Subject: ENGINE UNDERCOVER HARD TO REMOVE	Bulletin No: 09-012/07
	Last Issued: 03/30/2007

2004 - 2007 Mazda3

2006 - 2007 Mazda5

2007 Mazdaspeed3

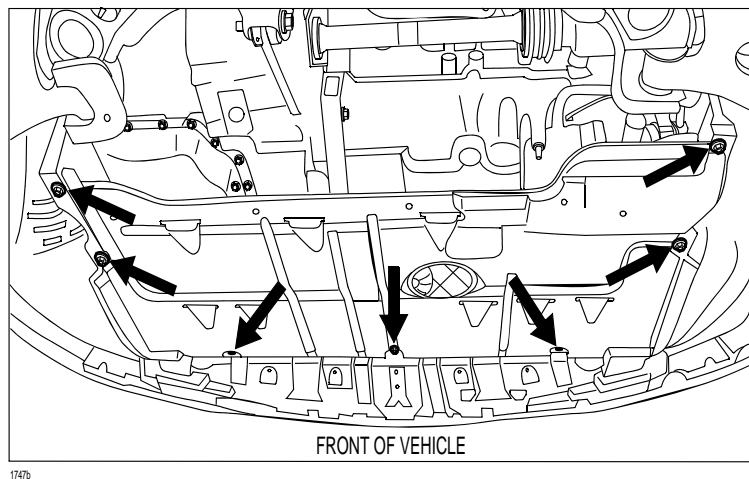
On some vehicles, the undercover may be hard to remove because the clip-nuts are rusted on the bolts due to road salt. When this happens, the complete clip spins or the spot weld breaks and the nut spins separately from the clip when loosening the bolts. The clip-nuts can be serviced separately from the undercover, and modified clip-nuts are now available with the thread integrated into the clip base.

When you receive a complaint that the undercover is hard to remove because the clip-nuts are rusted, replace the clips-nuts with the modified ones, and if needed, the bolts. There are seven bolts that hold the undercover in place - two along each side and three across the front. The modified clips-nuts are for along the sides. If the clip nuts across the front are damaged, replace them and the bolts, if needed. The bolts used for the sides and the front of the undercover are the same.

- The original bolts for the under cover (PN: 90720-0620) are 20mm long. In place of these bolts 16mm long bolts may be used (PN: 90720-0616). Although the 16 mm bolts are more difficult to align and install, less thread is exposed above the clip-nuts when used, reducing the chance of corrosion.
- Before installing the bolts, apply anti-seize compound to the bolts.
- Reuse the undercover if possible, however if it is broken, replace it with a new one.
